In re application of Kei-Yu Ko )  
Serial No. 09/579,402 )  
Filed: May 25, 2000 ) Art Unit  
For: GATE STACK STRUCTURE ) 2815  
Examiner: Eugene Lee )

PROPOSED DRAWING CORRECTIONS

FIG. 5

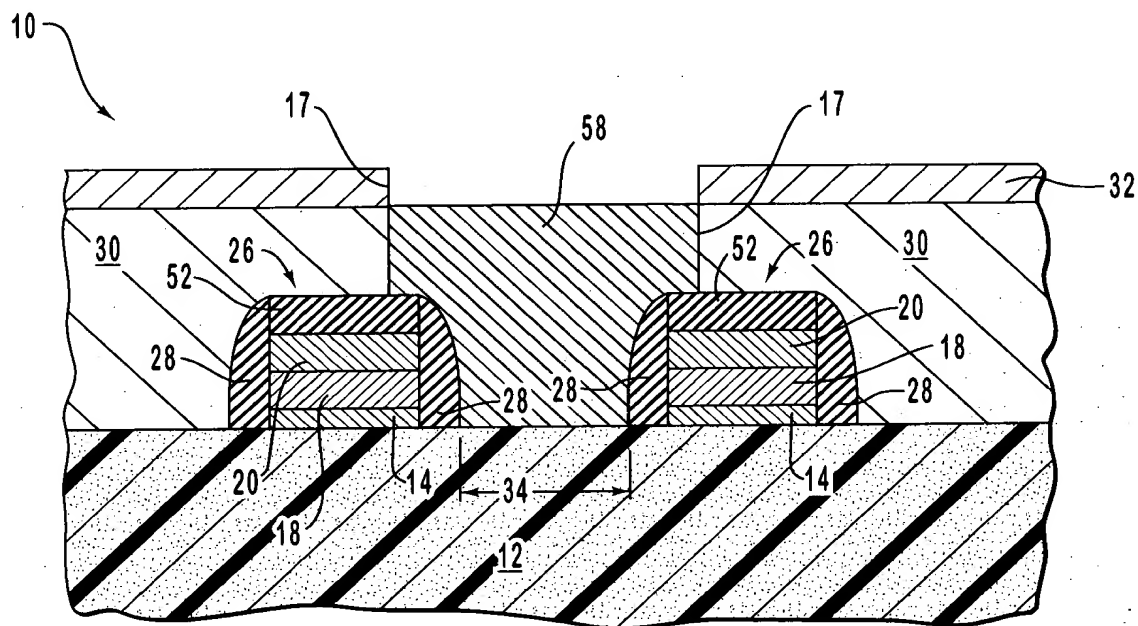
Figure 5 shows the same view that is displayed in Figure 4 with second selected pattern 17 replaced by conductive material 58 upon contact 34 between spacers 28. This feature is fully supported by the specification as filed. For example, the unamended Application recites as follows: "A conductive material is formed upon contact 34 between spacers 28 within second selected pattern 17". Application, p. 13, *ll.* 12-13. The remaining features and reference numerals displayed in Figure 5 are the same as those shown in Figure 4.

FIG. 6

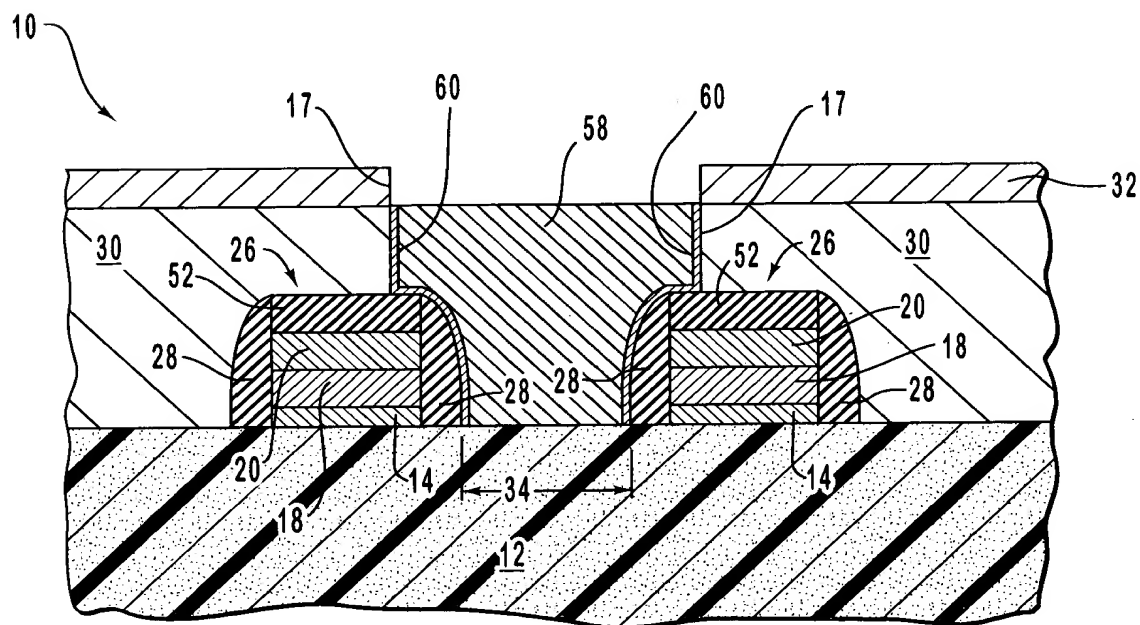
Figure 6 shows the same view displayed in Figures 4-5, where the contact plug has a layer of refractory metal or refractory metal silicide 60 proximate thereto. This feature is fully supported by the specification as filed. For example, the unamended Application recites as follows: "The conductive material will form a contact plug to contact 34. It may be desirable to clad the contact plug with a refractory metal or a refractory metal silicide. As such, second selected pattern 17 would have proximate thereto the refractory metal or silicide thereof prior to formation of the contact plug in contact with contact 34." Application, p. 13, *ll.* 13-17. The remaining features and reference numerals displayed in Figure 6 are the same as those shown in Figure 4.
